**RTCA Special Committee 209 / EUROCAE WG49**

**ATCRBS / Mode S Transponder MOPS Maintenance**

**Loss of Mode A Code change alert after a switch-off/on**

**Revision 1**

### 2.2.18.2.7 Flight Status and Vertical Status Protocols (Figure 2-17)

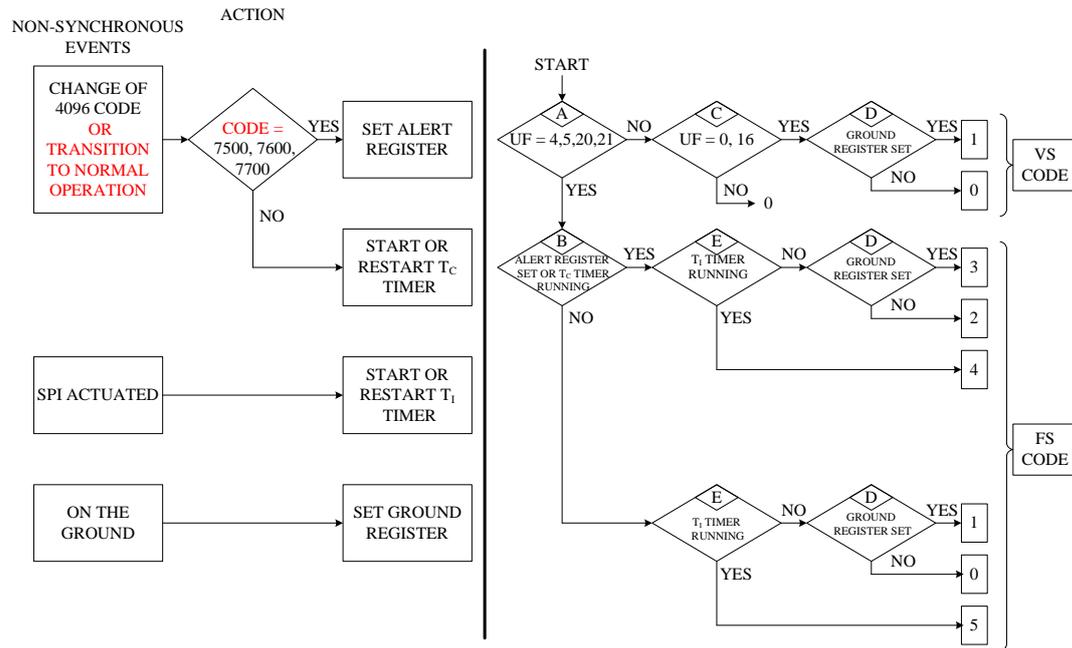
This WP proposes to come back on this issue and to eliminate the loss a Mode A code change by requiring the transponder to set an alert once it is leaving the Off or standby condition. Similarly this WP is also proposing to force the broadcast of the data-link capability register when leaving the standby condition. The case of the aircraft Identification needs to be discussed as it is a data not changing very often.

When the transponder transitions to normal operation (see §2.1.7.c) it shall initiate a temporary alert for 18 +/- 1 seconds.

In this case Fig 2-17 should be modified as follows:
